Watts Bar Nuclear Plant, Unit 2
NRC Docket No. 50-391

**Subject: Watts Bar Nuclear Plant (WBN) Unit 2 – Safety Evaluation Report
Supplement 22 (SSER22) - Response to NRC Required Action Items**

ENCLOSURE 1

Response to Action Items From Appendix HH of NUREG-0847, Supplement 22

WBN-EEB-EDQ000-999-2007-0002, R0

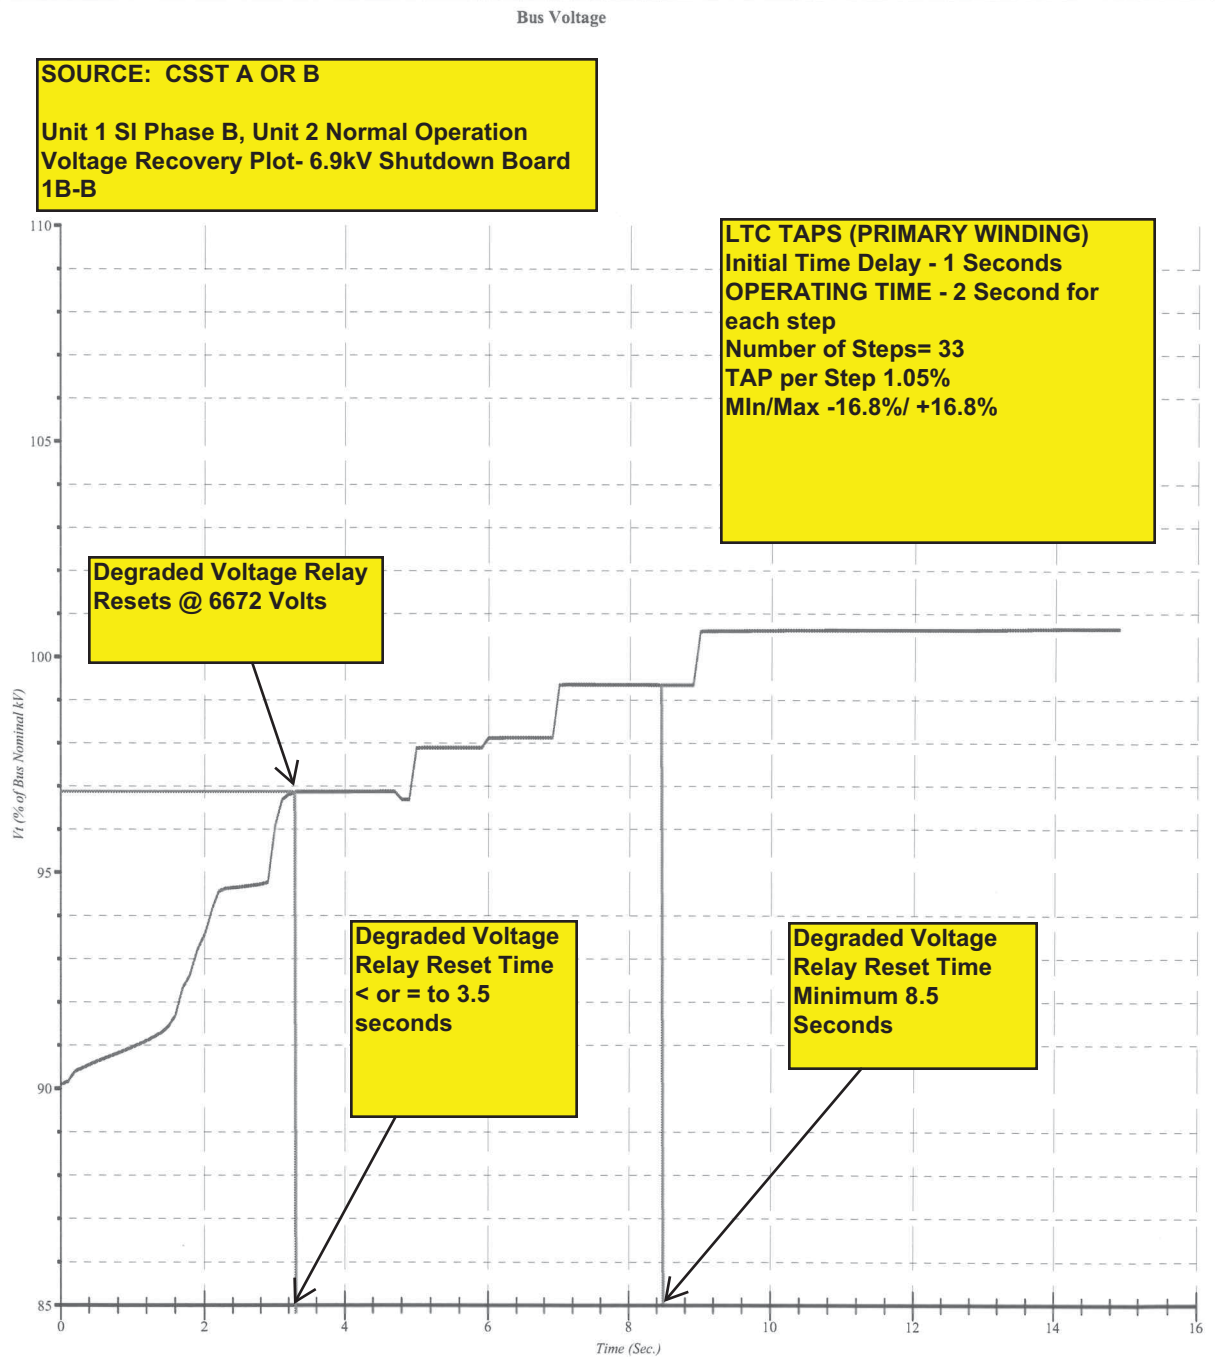
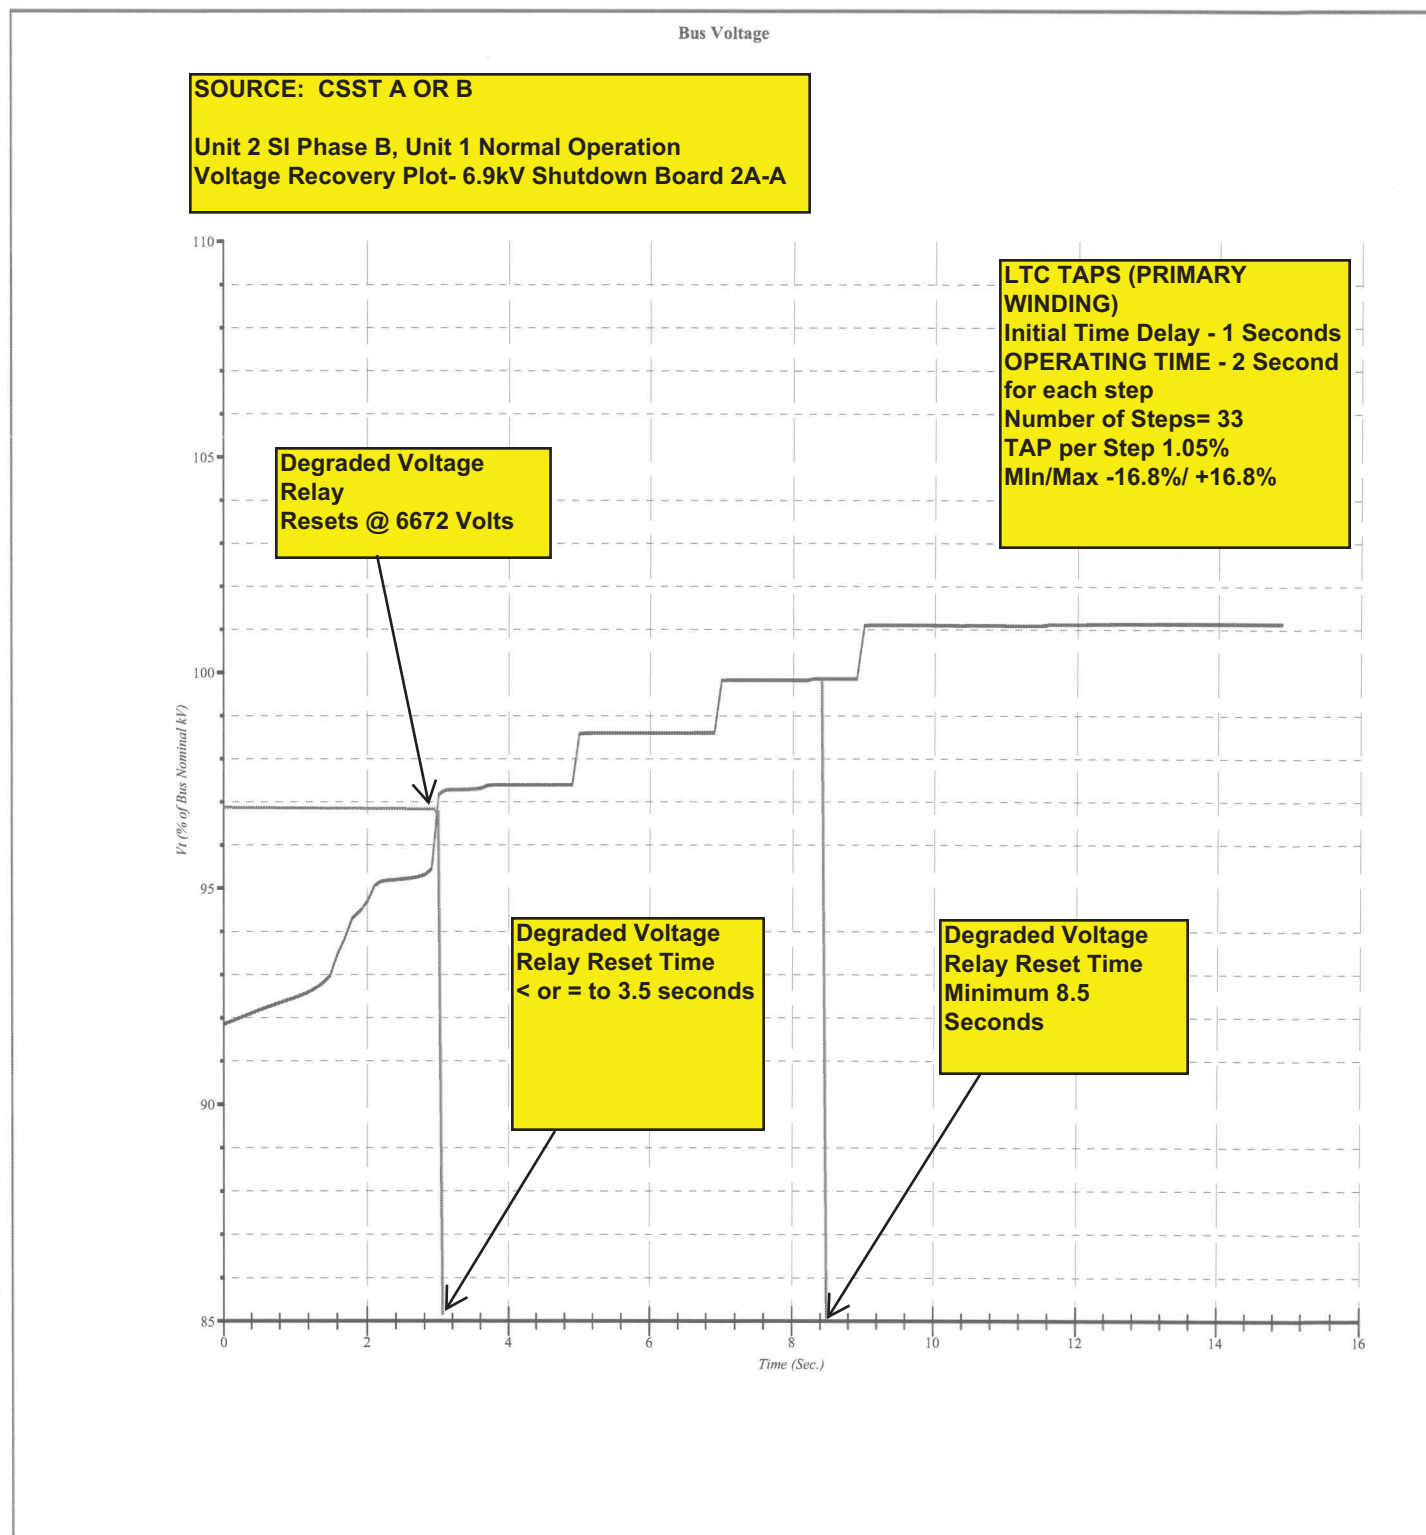
28. *TVA should provide to the NRC staff a detailed discussion showing that the load tap changer is able to maintain the 6.9 kV bus voltage control band given the normal and post-contingency transmission operating voltage band, bounding voltage drop on the grid, and plant conditions. (Section 8.2.2)*

Response: For CSSTs C and D, the load tap changer (LTC) is set to regulate 6.9kV shutdown board voltage at 7,071V (102.5%). For CSSTs A and B, the LTC is set to regulate the voltage at the 6.9kV start buses (which can power the 6.9kV shutdown boards through the 6.9kV unit boards) at 7,071V (102.5%). The upper and lower setpoints of the dead bands are 7,132V (103.4%) and 7,010V (101.6%), respectively. The dead band considered is $\pm 82.2V$ equivalent to the operating tolerances identified for these setpoints. The LTCs have the following parameters:

The analysis evaluates the 6.9-kV shutdown board minimum voltage requirements considering a maximum (bounding) grid voltage drop of 9 kV and a minimum grid voltage of 153kV and all plant conditions. Although the calculated shutdown board voltage falls below the degraded voltage relay dropout setpoint due to block start of ESF motors, it recovers above the degraded voltage relay reset setpoint in ≤ 5 seconds. The minimum time for the degraded voltage relays to isolate the offsite power from the 6.9kV Shutdown Boards is 8.5 seconds.
